TfNSW Reference: SYD20/01461/04

DPIE Reference: DA 10649

**RESPONSE TO FURTHER SUBMISSIONS - DIGITAL ADVERTISING SIGNS - M2
MOTORWAY EPPING**

M2 Digital Billboard Advertising Sign Road Safety Assessment - Railway Bridge Westbound

Figure 2.1: Location of the proposed billboard

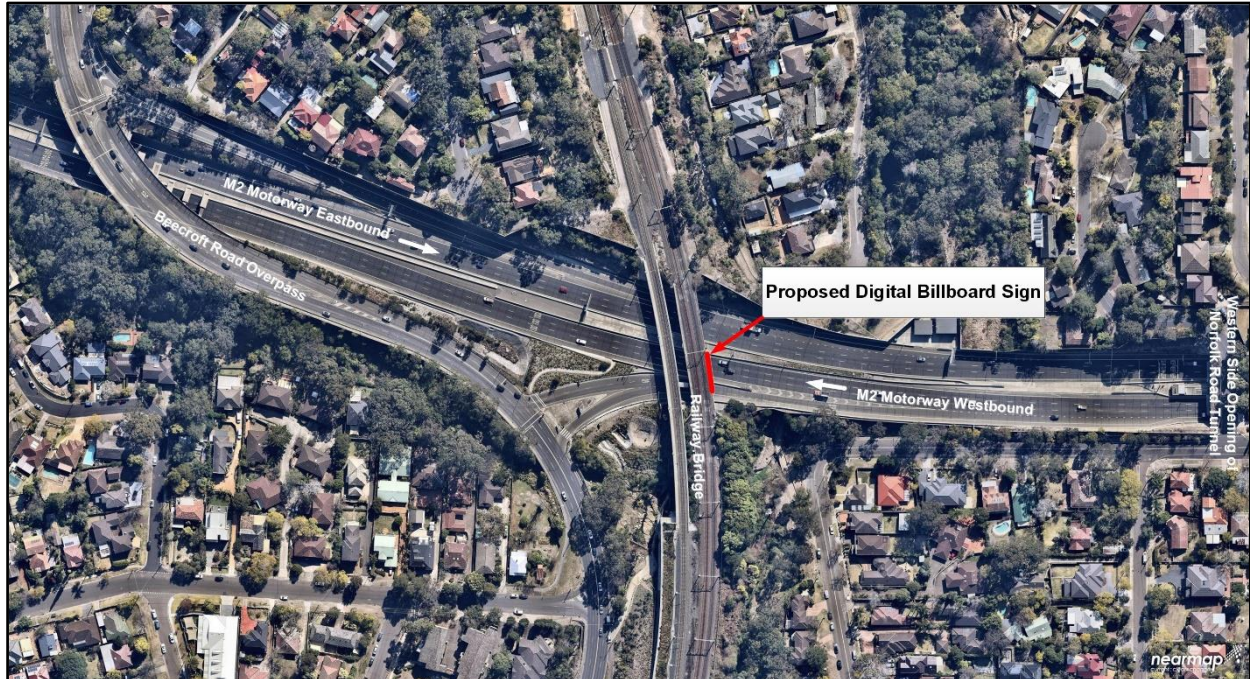
The location of the proposed digital billboard sign is affixed to the railway crossing over the M2 motorway, near the Beecroft Road exit facing westbound traffic as shown in Figure 2.1.

Figure 2.5: Cycle crossing, cycleway along the M2 and directional sign

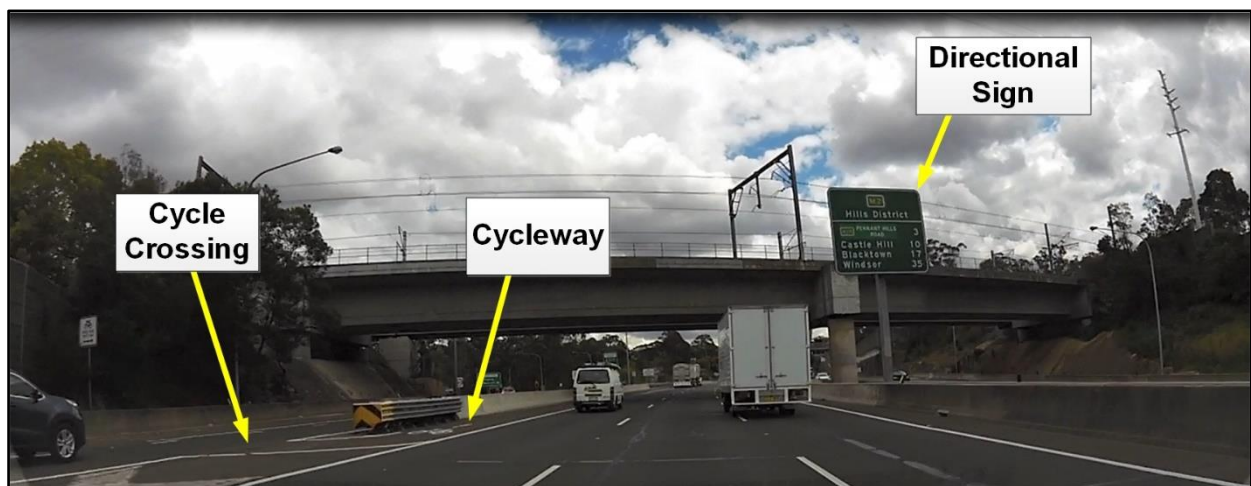
The bicycle crossing on the off-ramp and the cycleway along the M2 from the crossing, is located approximately 25 m from the proposed sign location (Figure 2.5).

A directional sign is located 15 m prior to the proposed location (Figure 2.5).

The cycle crossing on the off-ramp and the cycleway along the M2 from the crossing, is located approximately 25 m from the proposed sign location (Figure 2.5), which is within the stopping sight distance of 207 m for a 100 km/h speed limit.

A directional sign is located 15 m prior to the proposed location (Figure 2.5). The proposed location is in close proximity to this sign and would compete for attention with the directional sign.
